# Clearcreek Zoning Department

## Monthly Report

October 2022

## Peacock Ridge Preliminary Plan

**PRELIMINARY PLAN**  
 PEACOCK RIDGE  
 CLEARCREEK TOWNSHIP  
 WARREN COUNTY, OHIO

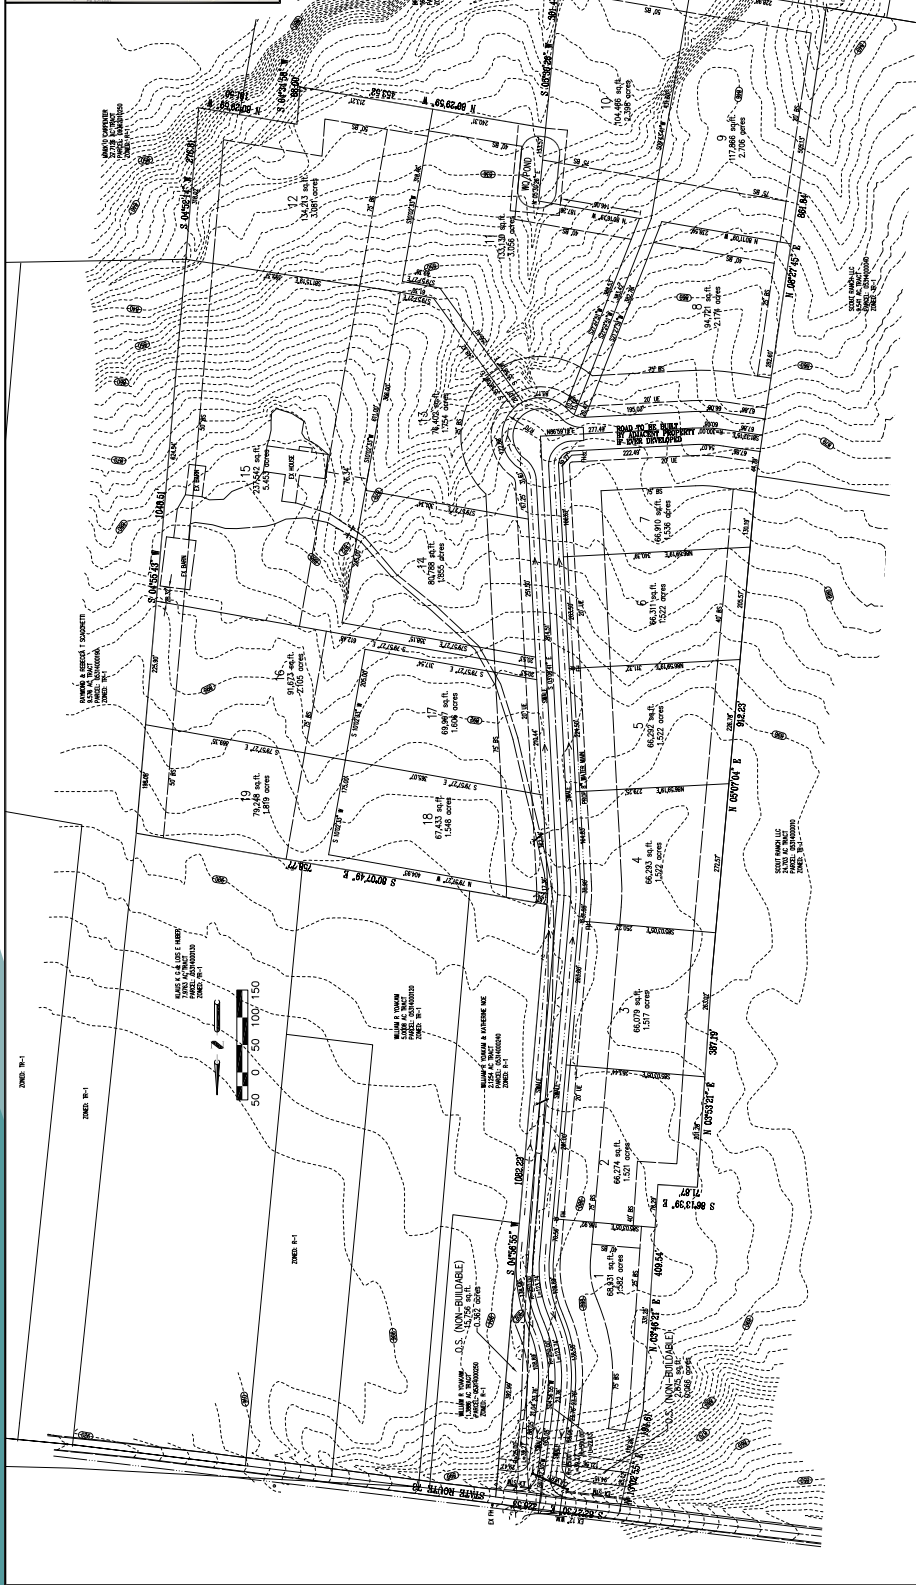
Zoning Director, Jeff Palmer reviewed the Peacock Ridge Preliminary Plan. It is the understanding of Mr. Palmer that the developer has been in discussion with the Warren County Regional Planning Staff regarding options for the required western street connection. As it is currently depicted, the northern boundary of Lot 8 would be adjacent to road right-of-way but not an improved ditch and pavement section.

The Clearcreek Township Zoning Resolution Section 5.10 states: "In every zone, any structure erected, or structure altered, or any permitted use, shall be located on a lot or tract having the frontage required by this Code on a dedicated, improved street or road." The Clearcreek Township Zoning Resolution Section 3.48 Lot, Frontage states: "The frontage of a lot is the length of the boundary of a lot that is coincident and in common with that of the road right-of-way of a public street, road or highway that it abuts."

Based on the former, zoning will require that the ditch and pavement shall be extended at least a distance of 120' to meet the minimum frontage requirement per Section 6.05 of the Clearcreek Township Zoning Resolution. This extension of ditch and pavement will provide the required lot frontage so that Lot 8 can be classified as a buildable lot. This extension of ditch and pavement will also serve as a second lot frontage boundary for Lot 7.

The existing northern barn (approximately 90'x55' in size) on Lot 15 if used residentially will be classified as a legal non-conforming use, since it is unable to meet the required rear yard setback (eastern setback).

All remaining lot layouts and lot sizes conform to the expectations of the Township Residence Zone "TR-1".
